## COMMENTS AND RESPONSES ON

### PROPOSED REVISION TO

#### **2008 LEAD (PB) NATIONAL AMBIENT AIR QUALITY STANDARD (NAAQS) COMPLIANCE PLAN – EXIDE TECHNOLOGIES-CANON HOLLOW FACILITY**

**Chart 1**

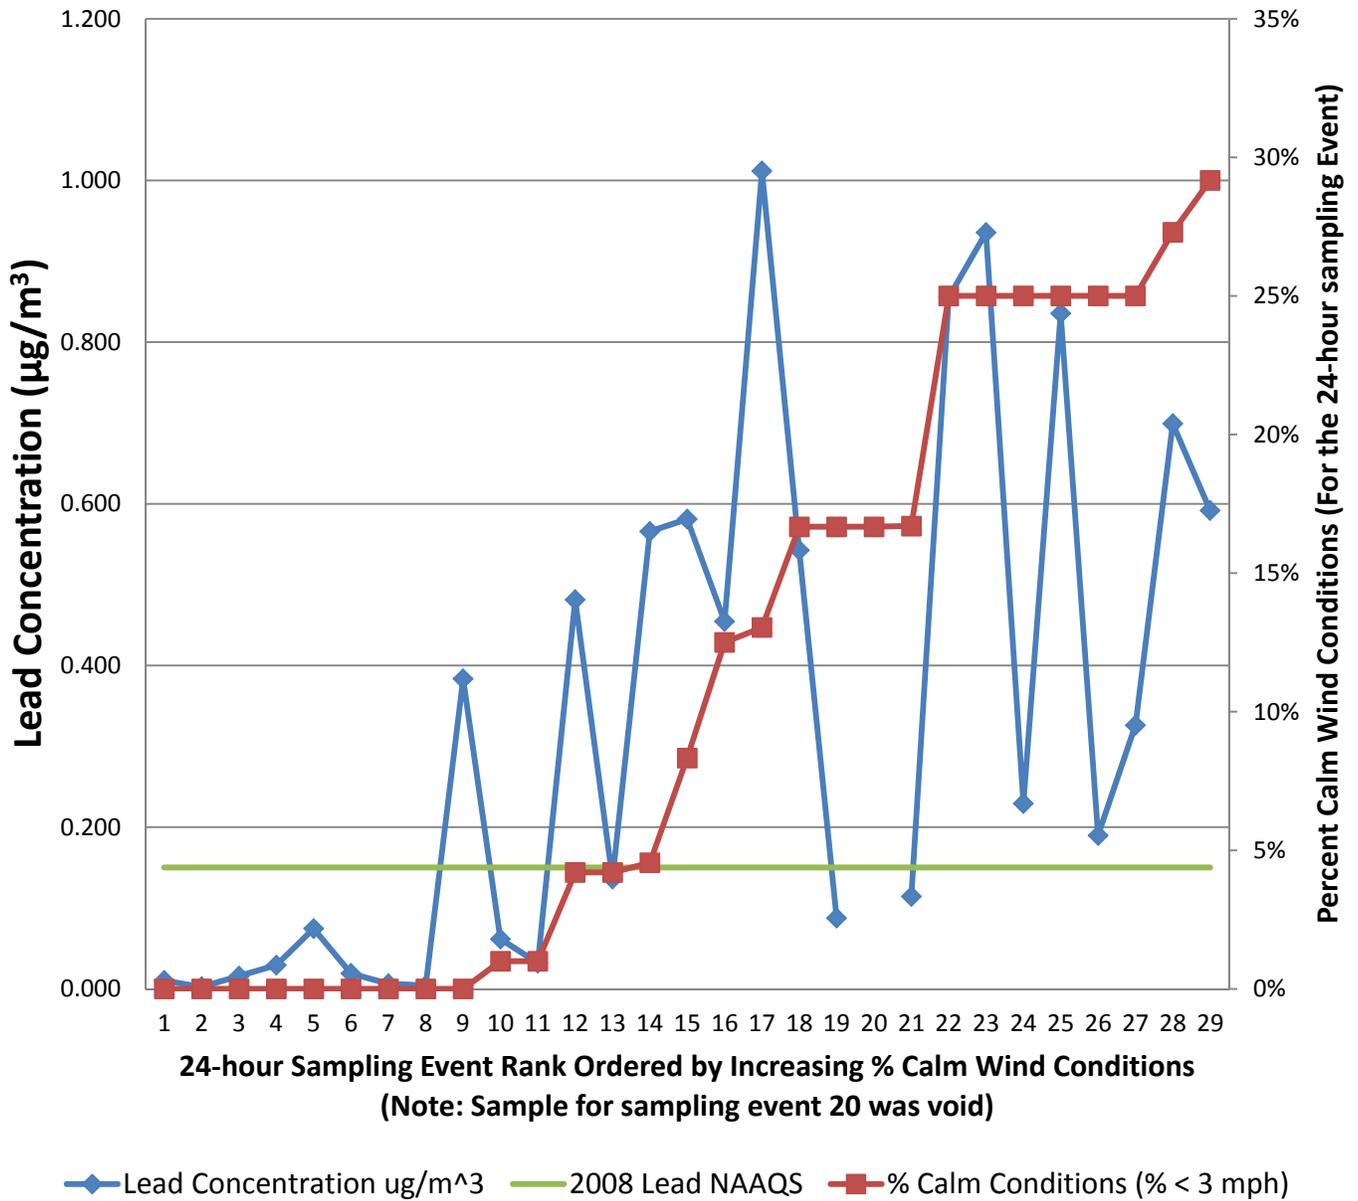
COMMENT #3: The commenter raises several concerns about the location of Forest City levee monitoring site. He notes reasons why the site is not ideal because of the direction of the prevailing wind, topography, and other siting criteria. Because of the location of the plan's maximum modeled result, he suggests a monitor location to the Northwest of the facility.

The Exide Levee ambient air monitoring site [EPA's Air Quality System (AQS) Site ID: 29-087-0008] is located approximately southwest of the smelter facility in an area that is subject to public access and considered in the ambient air. Analyses conducted by Air Program staff indicates that calm wind conditions tend to correlate with increasing airborne lead concentrations which suggests fugitive emissions are likely to be monitored at the Levee site despite the predominant wind direction. See **Chart 1** below. This weight of evidence supports the continued use of the levee site as an indicator of how effective the new emission controls and management practices are at controlling fugitive airborne lead emissions and provide airborne lead data for demonstrating that the area meets the lead NAAQS.
